REPORT TO PLANNING COMMISSION City of Sacramento

PUBLIC HEARING
July 28, 2011

Subject: Zansa Design (P11-024): A request to allow a concrete patio and solid fencing in the front yard setback area of an existing single family home in on 0.17 acres in the Standard Single-Family (R-1) zone.

Exhibit 1A: Site Plan

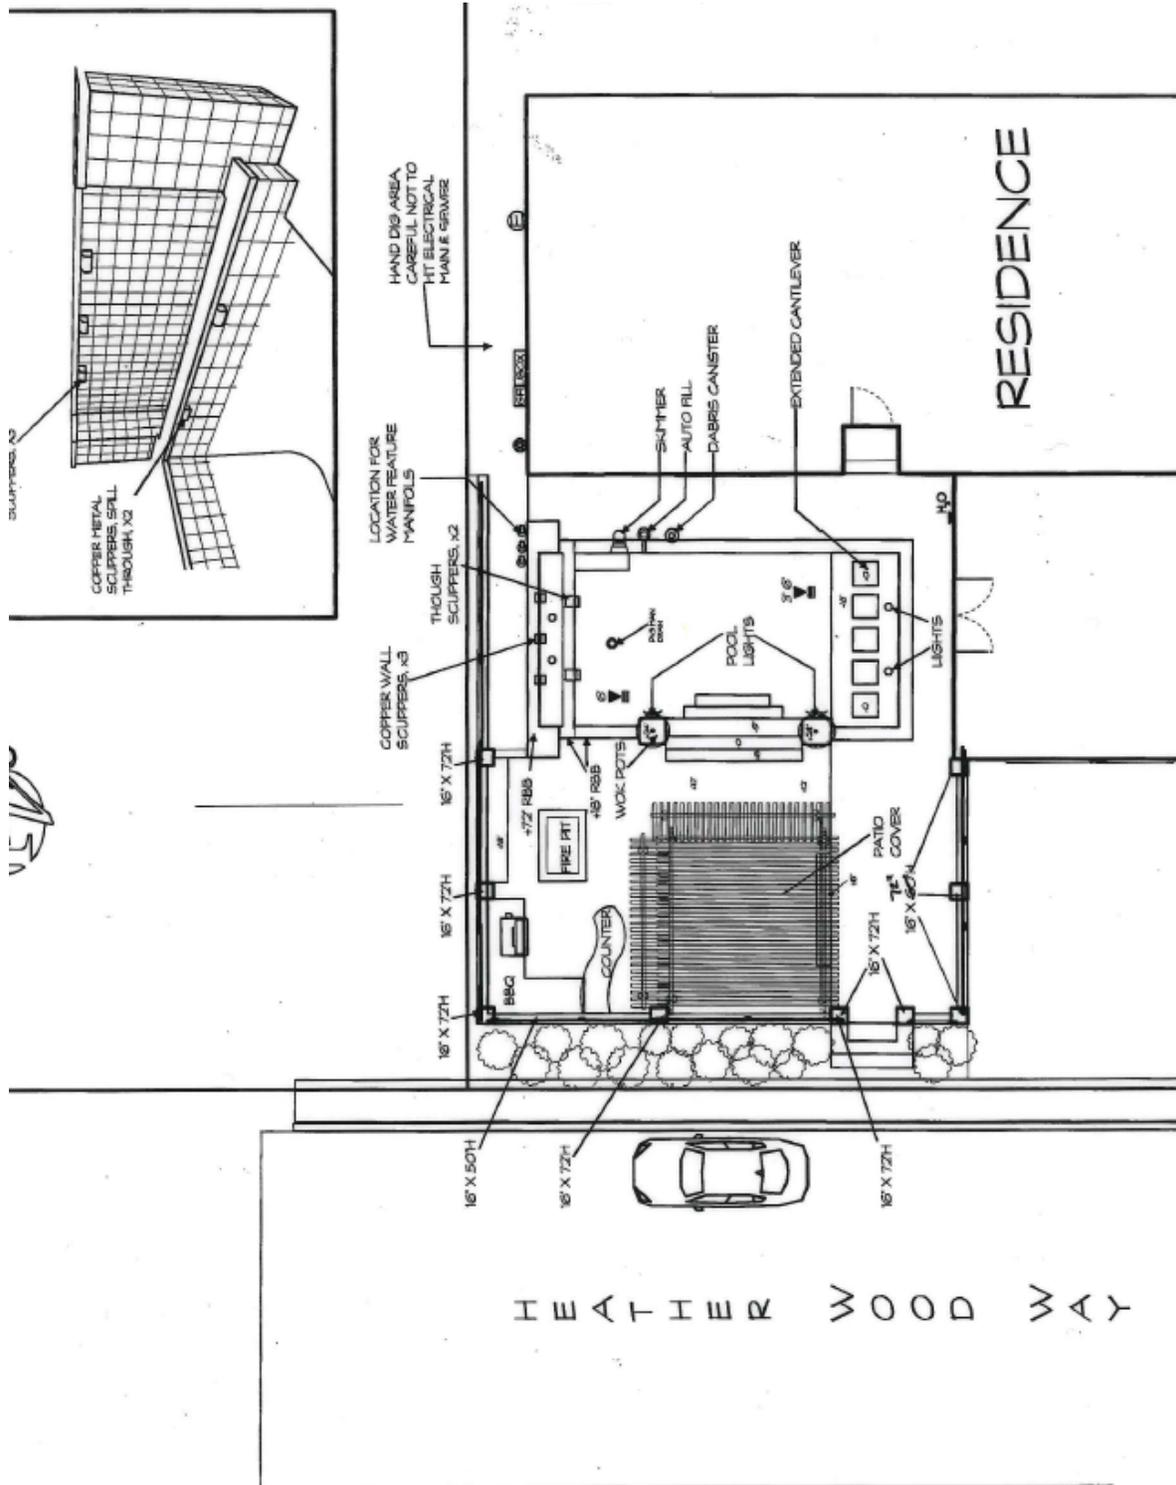
The project requires variances to exceed the 40% paving allowance for the front-yard setback area for the patio and to install a semi-closed metal fencing in the upper portion of the surrounding. As summarized in the project background, the applicant constructed the concrete patio for the pool not knowing that it exceeded the 40 percent paving maximum for the front yard setback area. With the installation of the patio, approximately 89% of the front-yard setback area is covered with concrete. Once the code enforcement case was initiated for the site, the paving of the patio was completed.

B1. The patio cover structure depicted on the plans shall not be allowed. Such structure requires an entitlement to locate a patio cover within the front yard setback.
